Source: MOTOROLA

Title: Proposal for improvement of Tx diversity closed loop modes

Document for: Discussion and approval

Figure 2. Format of feedback signaling message. FSM_{po} transmits the power setting and FSM_{ph} the phase setting.

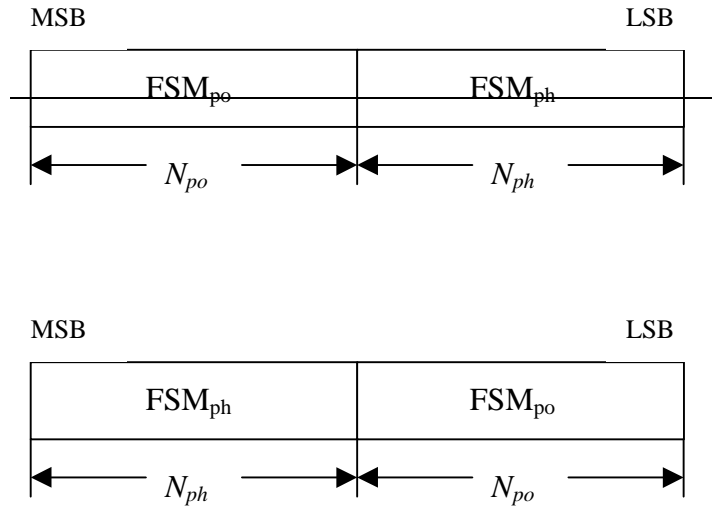
FBI D field (see 25.21). Each message is of length $N_W = N_{po} + N_{ph}$ bits and its format is shown in the ~~Figure 2~~ ~~Figure 2~~ ~~Figure 2~~. The transmission order of bits is from MSB to LSB, i.e. MSB is transmitted first. FSM_{po} and FSM_{ph} subfields are used to transmit the power and phase settings, respectively.

8.4 Initialisation of closed loop Tx AA modes for normal and slotted mode

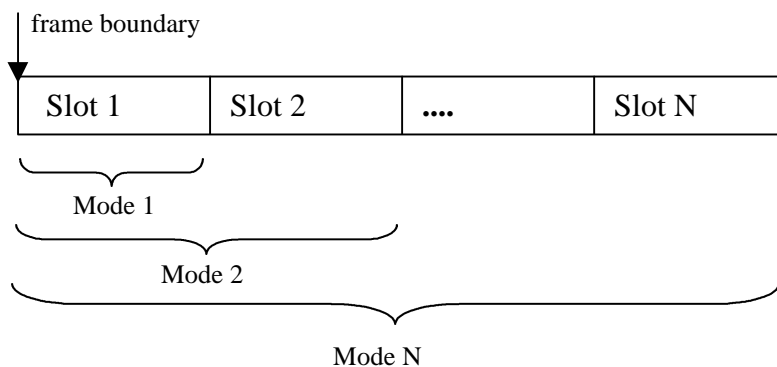
At the starting point, either

- in normal operation at the beginning of the first frame of transmission, or
- upon resumption after slotted mode operation at any slot time in a frame,

the following approaches are used.

For normal operation initialisation with $N_{\text{FBD}}=1$, the feedback commands sent by the UE are progressively updated with increasing resolution as defined by increasing mode number from mode 1. The UE selects from the set of Weights allowed given the previously transmitted bits of the feedback message.

With $N_{\text{FBD}}=2$, the normal operation initialisation the feedback commands sent by the UE are progressively updated with increasing resolution as defined by increasing mode number

starting from mode 2. The UE selects from the set of Weights allowed given the previously transmitted bits of the feedback message.

For recovery after slotted mode with $N_{\text{FBD}}=1$, if transmission of uplink signalling information resumes part way through a FSM period, signalling for mode 1 is used on the remaining slots of the partial FSM. Normal initialisation then occurs if the N slot initialisation period does not contain the last FSM of the frame.

If the N slot initialisation period does contain the last FSM of the frame, Mode 1 signalling is used during this FSM period and normal initialisation occurs from the beginning of the next frame.

For recovery after slotted mode with $N_{\text{FBD}}=2$, if transmission of uplink signalling information resumes part way through a FSM period, signalling for mode 2 is used on the remaining slots of the partial FSM. Normal initialisation then occurs if the N slot initialisation period does not contain the last FSM of the frame. If the N slot initialisation period does contain the last FSM of the frame, Mode 2 signalling is used during this FSM period and normal initialisation occurs from the beginning of the next frame.
